SUBJECT: REVIEW OF PRELIMINARY ACCIDENT SEQUENCE PRECURSOR ANALYSIS OF  
CONDITION AT THREE MILE ISLAND NUCLEAR STATION, UNIT NO. 1

LER Nos. 289/97-007, -008, -010

Event Description: Failure of both generator output breakers causes a LOOP

**Licensee Comments**

Fig. 1 Three Mile Island switchyard.

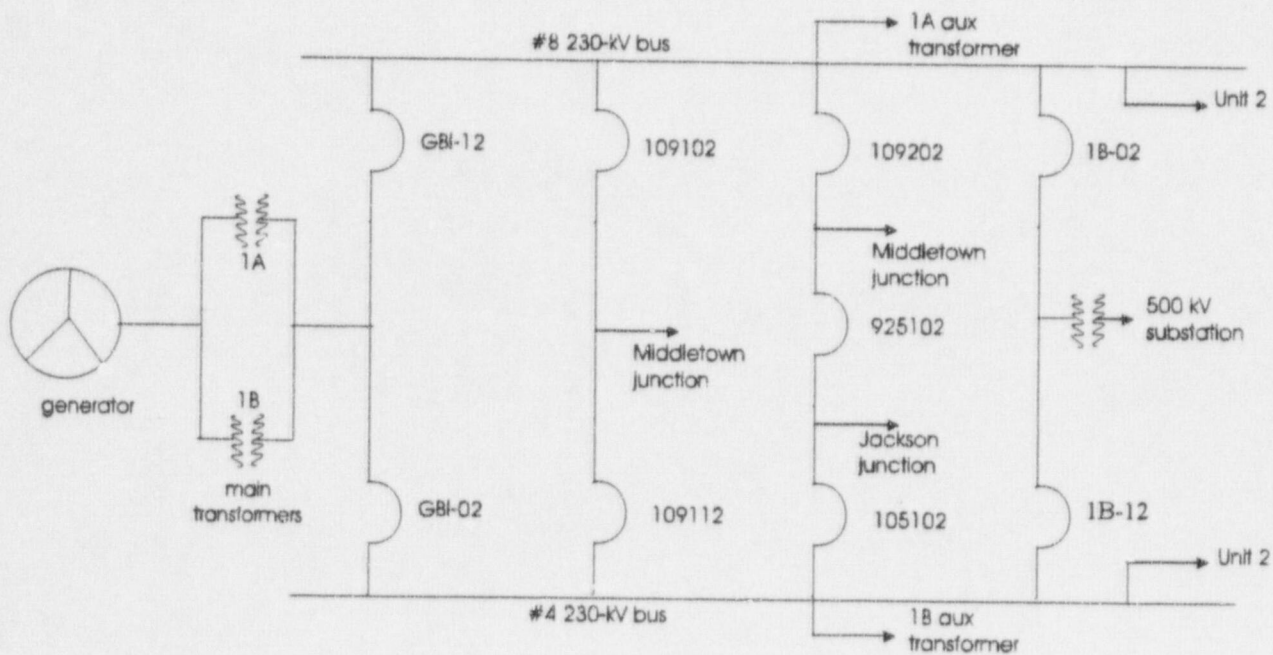
**Comment 1f:** Page 6, Fig. 1; change breaker identification from 1B-14 to 1B-12 per Gilbert/Commonwealth drawing 229-002.

**Response 1f:** The proposed figure change was made. This has no effect on the analysis results.
